OMAP-L138 SOM-M1 Errata

Hardware Documentation

This document contains errata information for the OMAP-L138 SOM-M1 and TMS320C6748 SOM-M1.

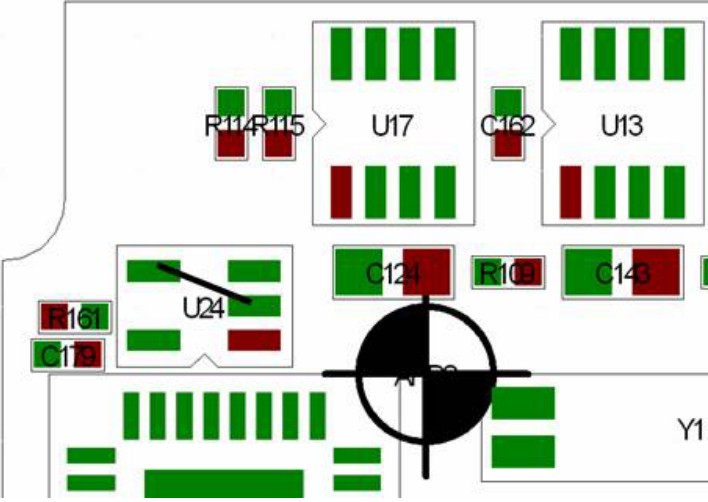
Errata ID	Summary	Details
<p>E0013</p> <p>FIXED</p>	<p>Title: INA219 pull-up resistors too strong</p> <p>Affected Part Number(s): 1014650, 1014651, 1014652, 1014613</p> <p>Release Date: 04/01/10</p> <p>Resolution Date: 09/29/10</p>	<p>Description: Communication with the INA219 may not function properly because the 1k ohm resistors are too strong.</p> <p>Work Around: Replace resistors R114 and R115 with 4.7k ohm resistors. See image below for resistor location. IMPORTANT NOTE: Any modification of the SOM voids warranty.</p>  <p>Fix Plan/Status: This issue has been resolved as of PCN 450.</p>
<p>E0014</p> <p>FIXED</p>	<p>Title: USB data line pull-down resistors</p> <p>Affected Part Number(s): 1014650, 1014651, 1014652, 1014613</p> <p>Release Date: 04/01/10</p> <p>Resolution Date: 09/29/10</p>	<p>Description: External resistors were added to the USB data line that duplicate internal resistors. USB use is not impacted by this issue, but the addition of external resistors does not follow the USB specification.</p> <p>Work Around: Remove resistors R153 and R154. See image below for resistor location. IMPORTANT NOTE: Any modification of the SOM voids warranty.</p>
